CEN-268, REVISION 1  
SUPPLEMENT 1-NP, REVISION 1-NP

**RESPONSE TO NRC REQUEST  
FOR ADDITIONAL INFORMATION  
ON CEN-268**

PREPARED FOR THE C-E OWNERS GROUP BY  
TRANSIENT METHODS AND LOCA GROUP  
NUCLEAR FUEL ENGINEERING

MAY 1987

FIGURE 1  
2700 MW<sub>T</sub> PLANT ANALYSIS  
0.1 FT<sup>2</sup> HOT LEG BREAK  
STEAM BYPASS SYSTEM OPERATIONAL  
BREAK FLOW

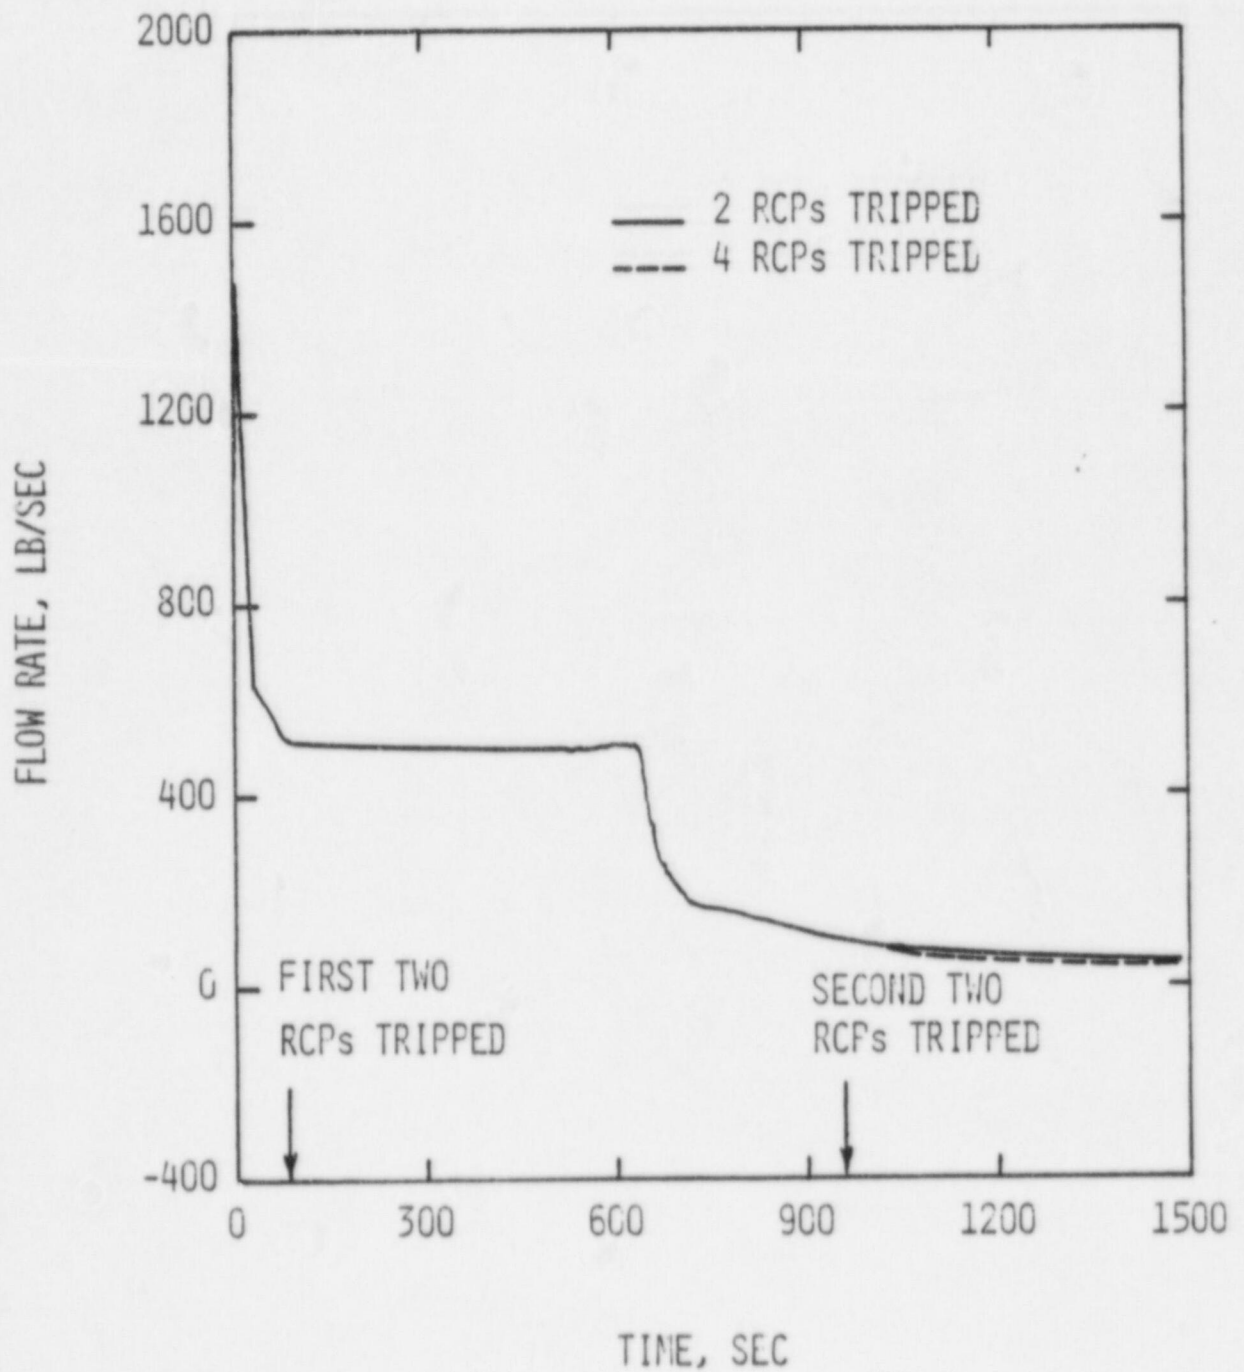
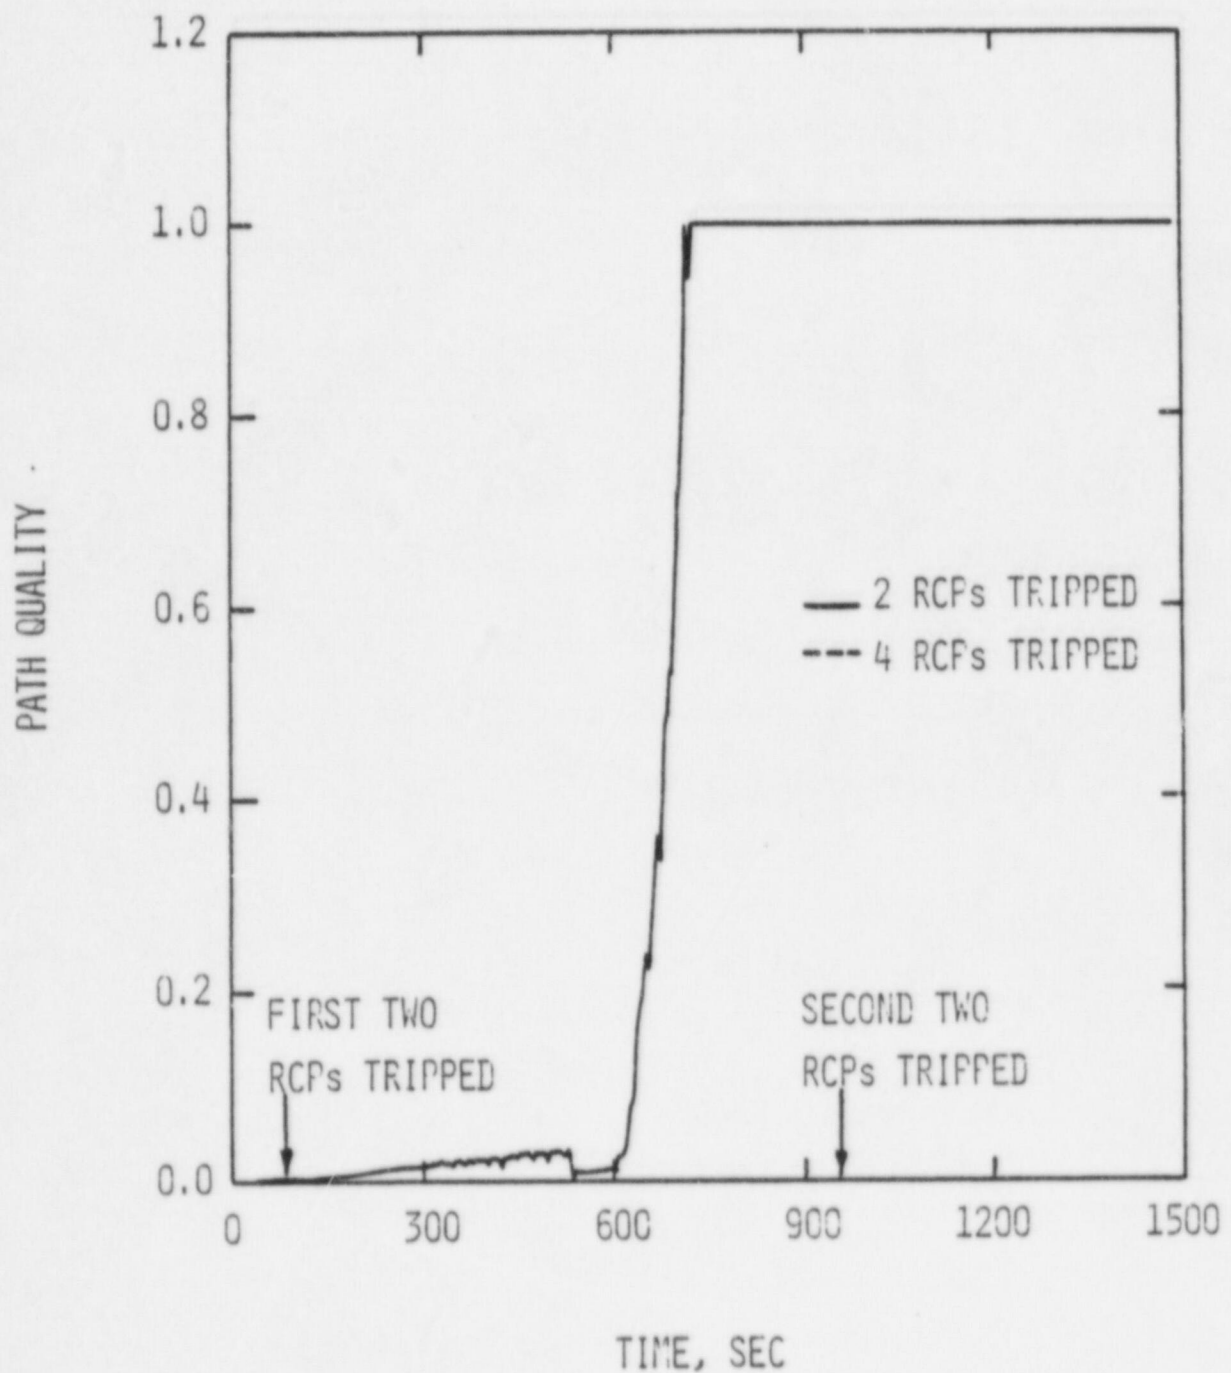
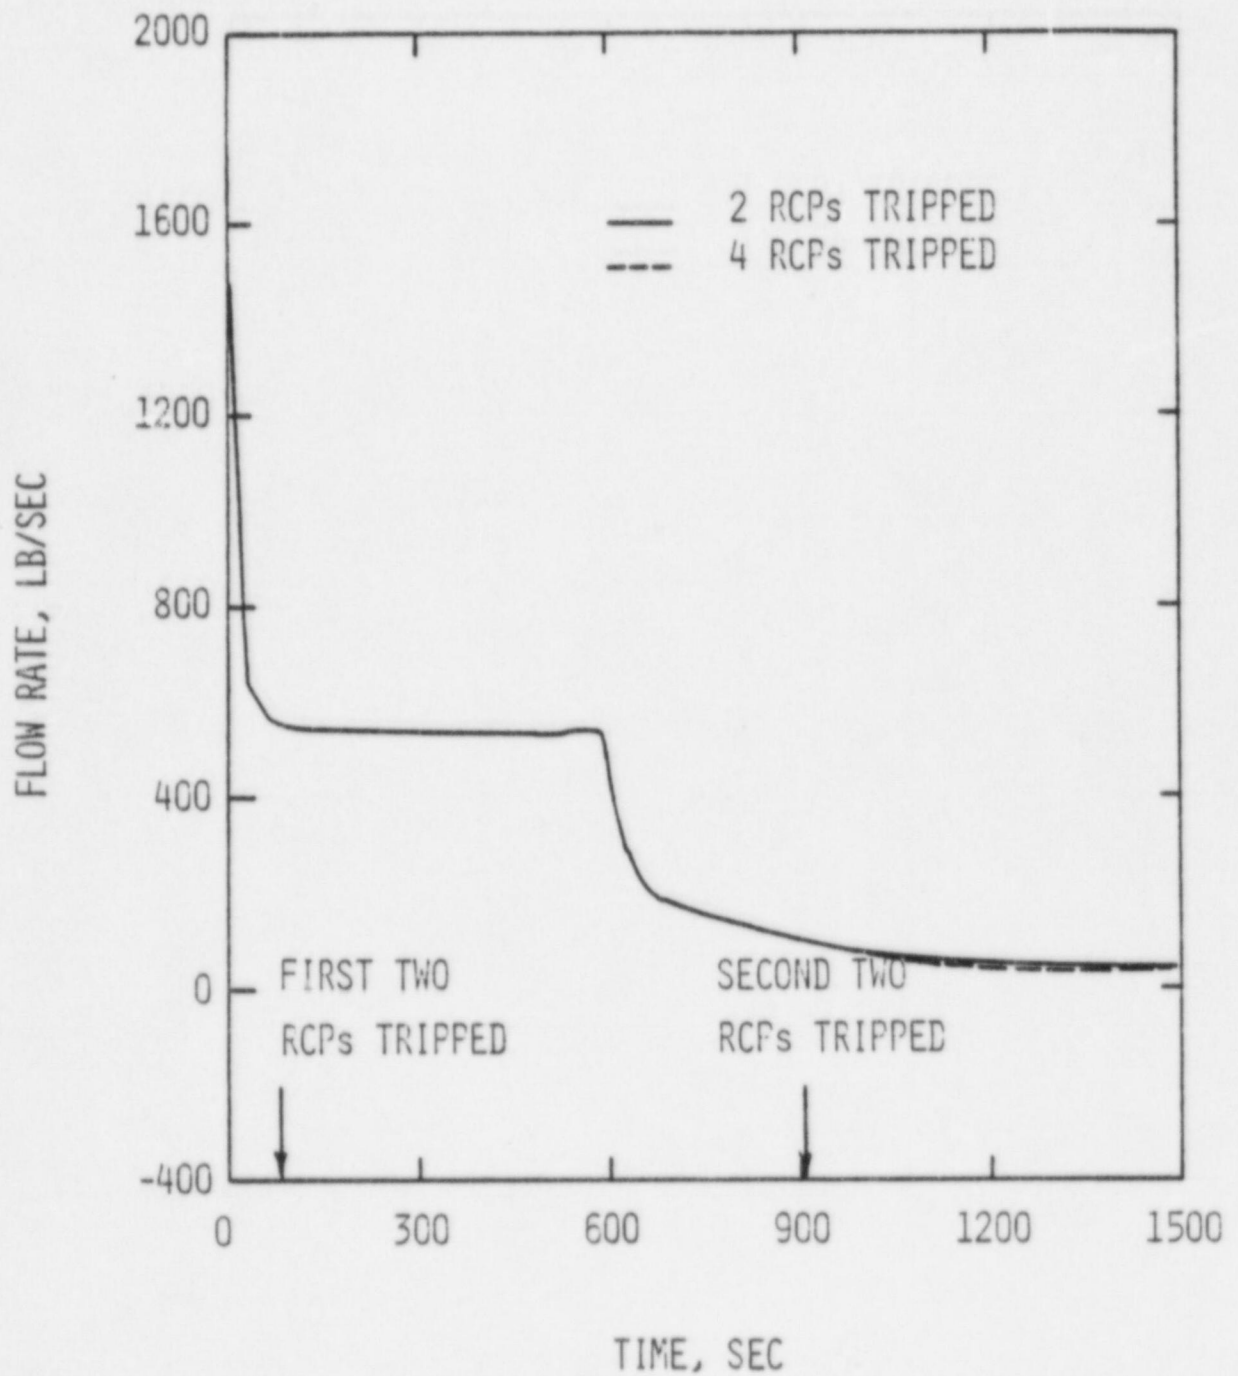
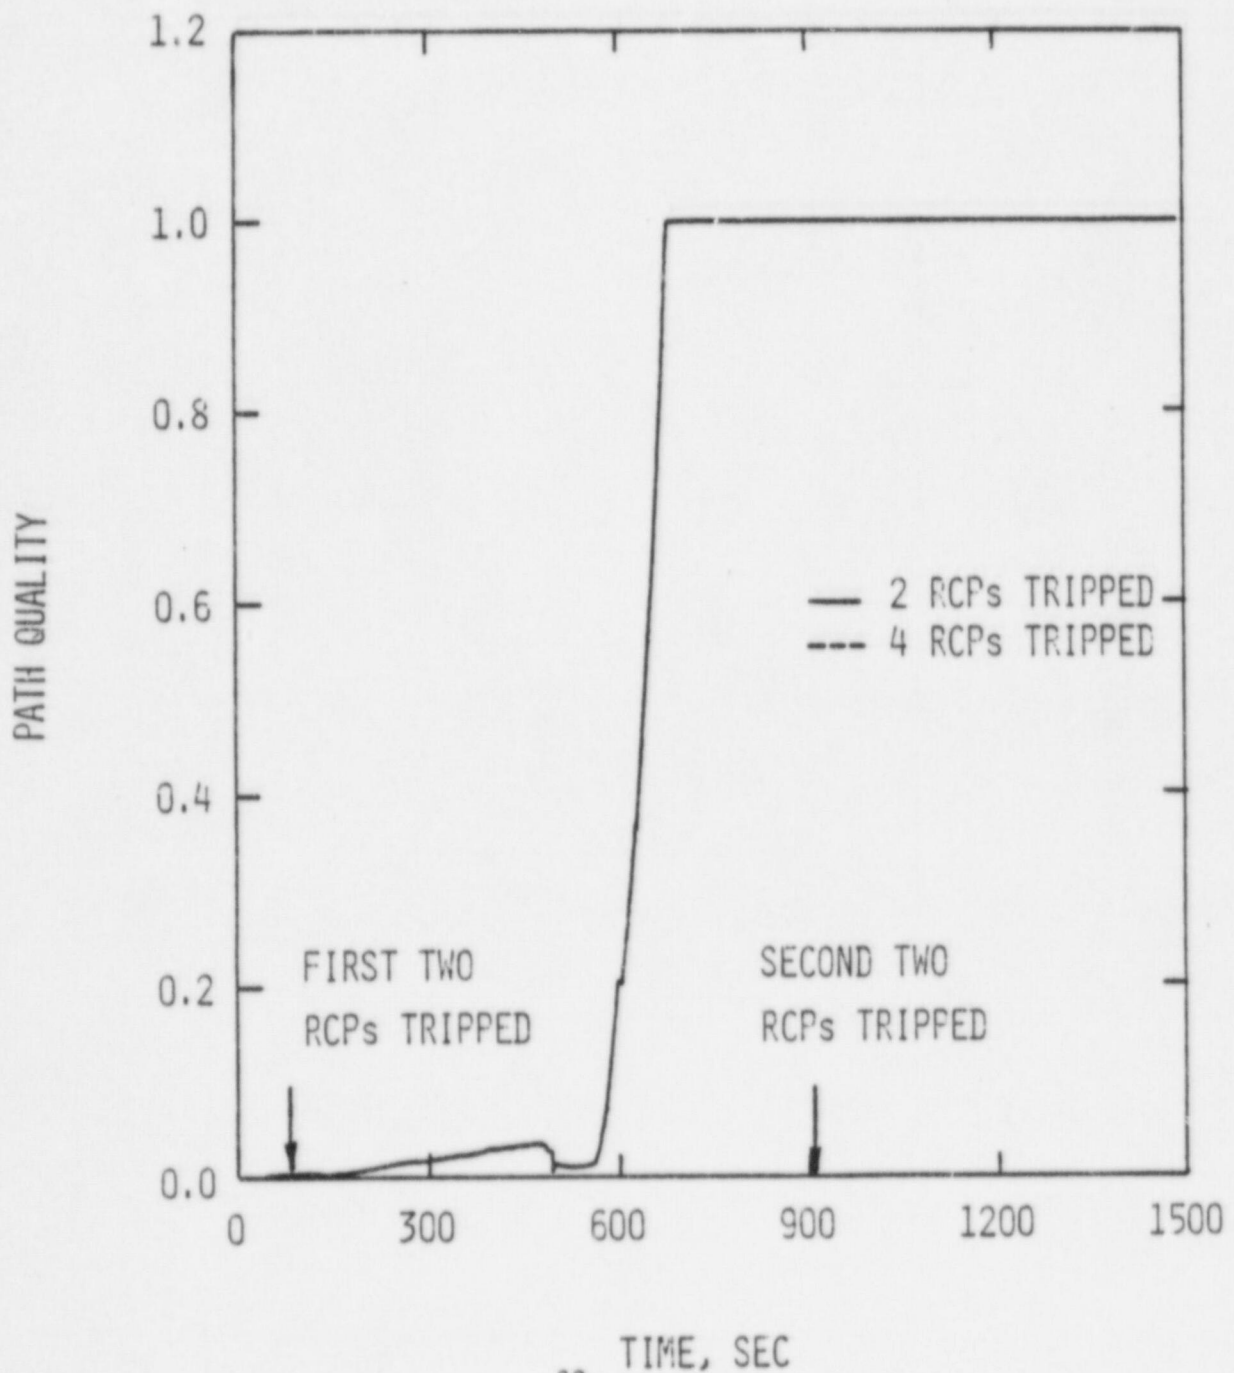
Question 8: What are the break flow and void fraction in the hot leg near the break for the two cases shown in Figs. 3-1 to 3-6? Provide the data in graphical form.

Response: As agreed at the October 4, 1984 meeting, plots of break flow and quality near the break would provide an acceptable response to this question. The plots which correspond to the two computer cases presented in Figures 3-1 to 3-6 for the 2700 MWt Reference plant with the steam bypass system operational and with the MSSVs in operation are provided in Figures 1 through 4, respectively. Refer to the CEFLASH-4AS nodal diagram provided in Figure 11 for the location of flow path 3.

FIGURE 5  
3410 MW<sub>T</sub> PLANT ANALYSIS  
.05 FT<sup>2</sup> HOT LEG BREAK  
STEAM BYPASS SYSTEM OPERATIONAL  
BREAK FLOW

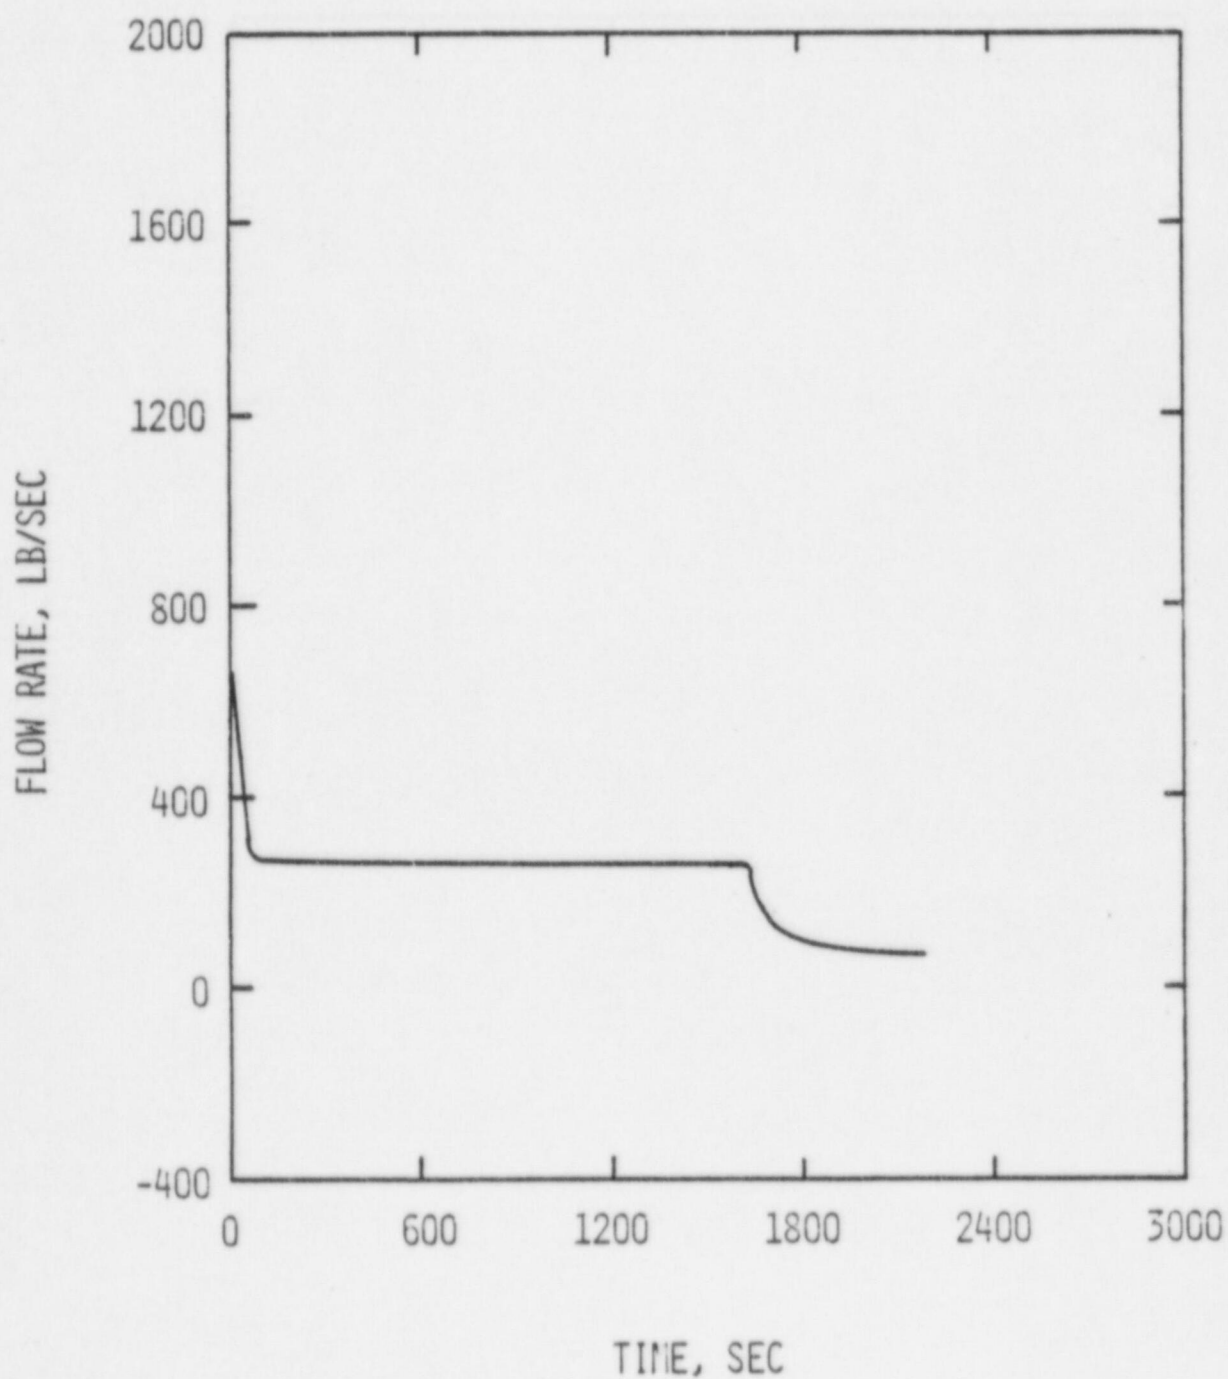
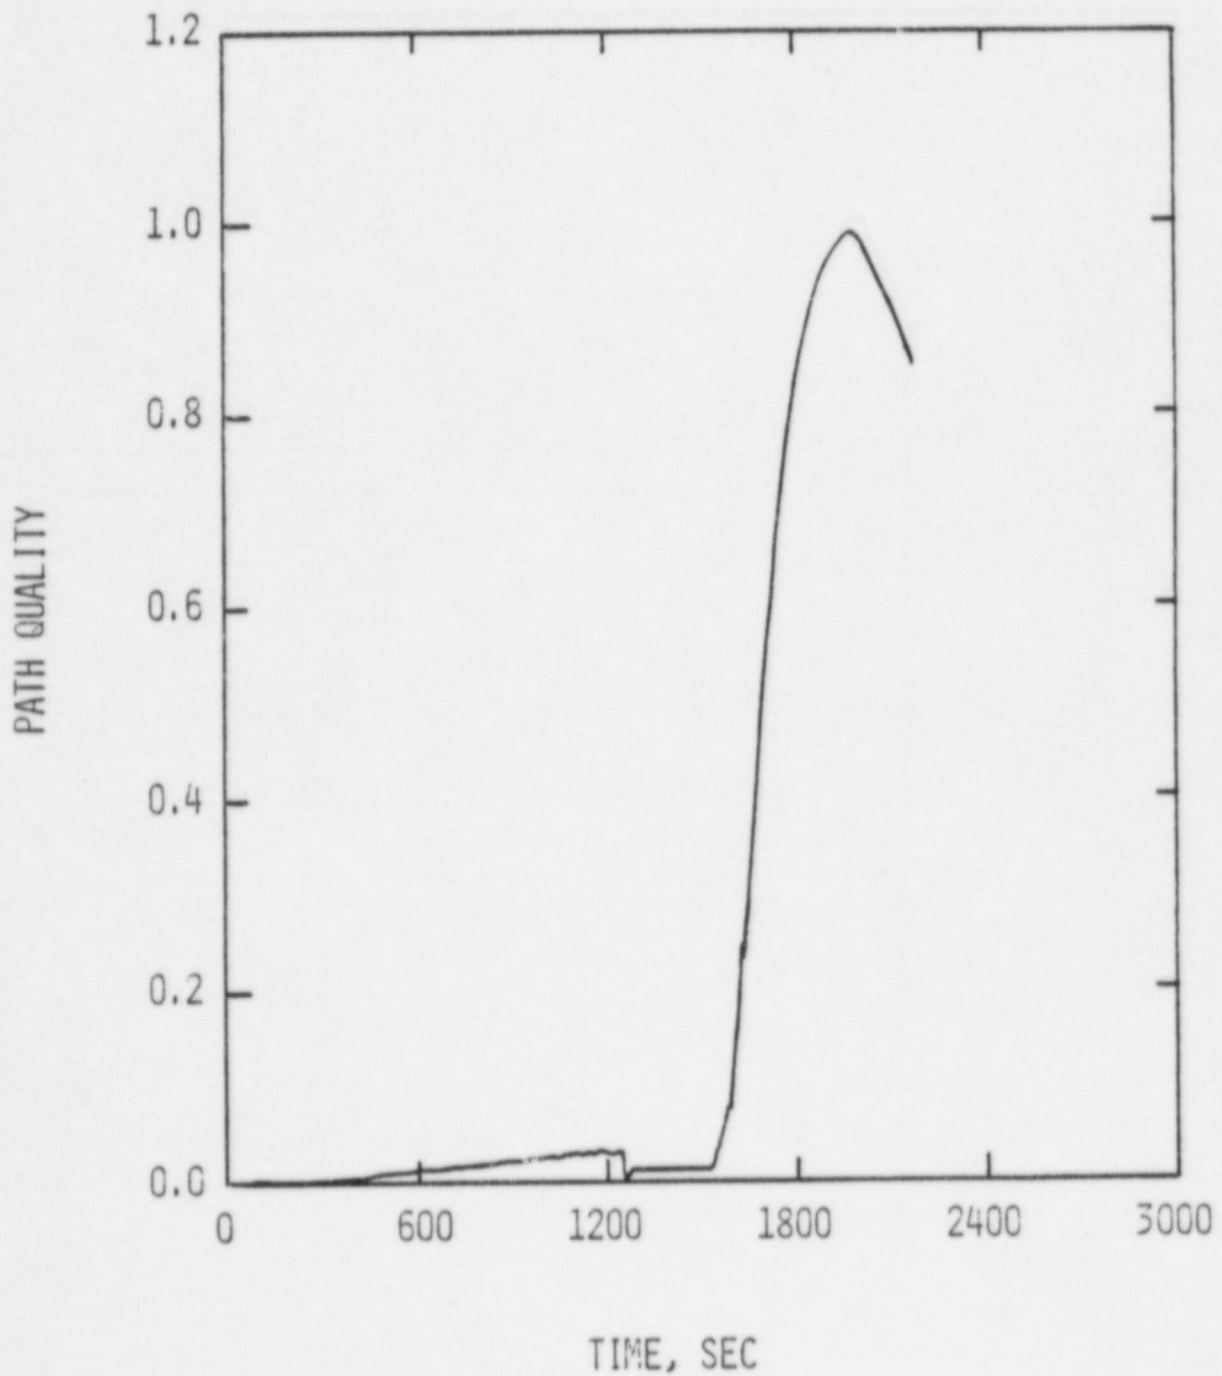
Question 13: Provide plots of break flow and void fraction in the hot leg near the break as a function of time for the 0.05 ft<sup>2</sup> break case.

Response: As agreed at the October 4, 1984 meeting, plots of break flow and quality near the break would provide an acceptable response to this question. These plots for the 3410 MWt plant analysis are provided in Figures 5 and 6, respectively.
